T J Booth Associates. Consulting Engineers 20A Eastgate St, Rochdale OL16 1DH	Project				Job Ref.	
	GB Services - Riverside Business Park (Proposed Unit 3)				rep-tjba-GBS-riveside business park-units 3-UU CONSULTATION RESPONSE-230625.docx	
	Section				Sheet no./rev.	
	UU Consultation Response				1 / 0	
	Calc. by	Date	Chk'd by	Date	App'd by	Date
	DS	23/06/2025

Revision	Date	Reason
0	Jun 2025	Response to UU consultation dated 27-MAR-25.

UU consultation dated 27-MAR-25, ref: DC/25/454.

Location : Riverside Motors Todmorden Road Littleborough Rochdale OL15 9EG
Proposal : Submission of details to comply with condition 5 (drainage) on planning permission 23/01374/FUL

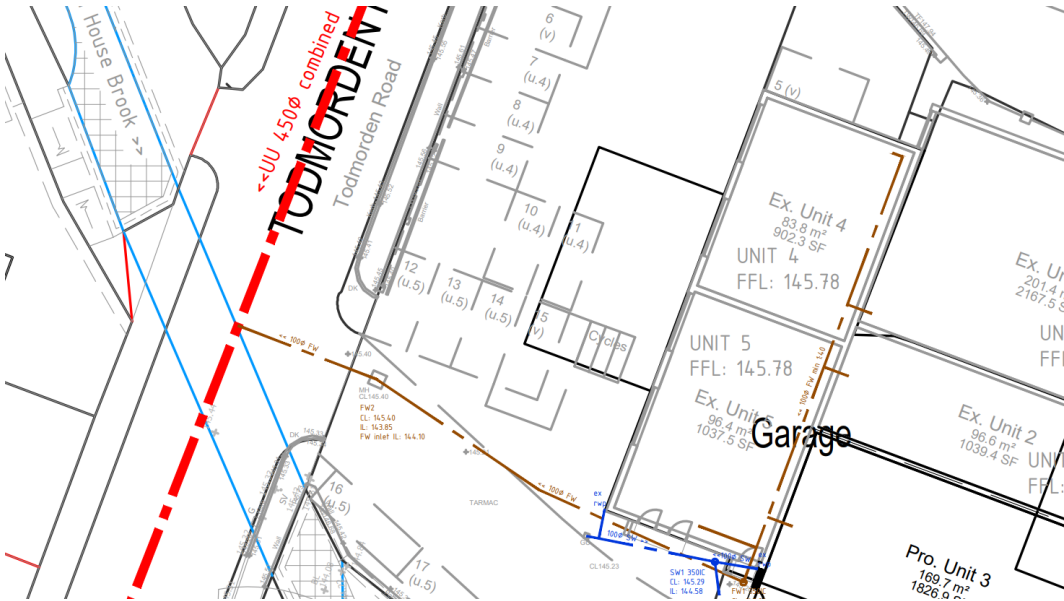
Further to our review of the submitted documents, Drawing DRAINAGE PLAN & DETAILS, - Dated Jan 2025 United Utilities recommends that condition 5 is not discharged. This is because we would expect to see the ultimate discharge point for the proposed foul sewers.

The existing FW connection as recorded on the United Utilities sewer plan (below) is shown as a surface water connection. This is wrong and should be amended by UU. No surface water uses this connection. The existing and proposed surface water has a dedicated SW outfall to the adjacent river as shown on the TJBA drainage plan.

Please refer to full drainage design plan ref: dwg-tjba-GBS-riverside business park-drainage plan & details-rev1.

An excerpt of the FW connection is shown below. There is an existing historic FW connection to the 450mm combined UU sewer main in Todmorden Road.

The connection has been maintained as a FW connection in the renovation of the development.

The new unit (Unit 3) is proposed to connect to the FW site drainage and thereby also reusing this connection.
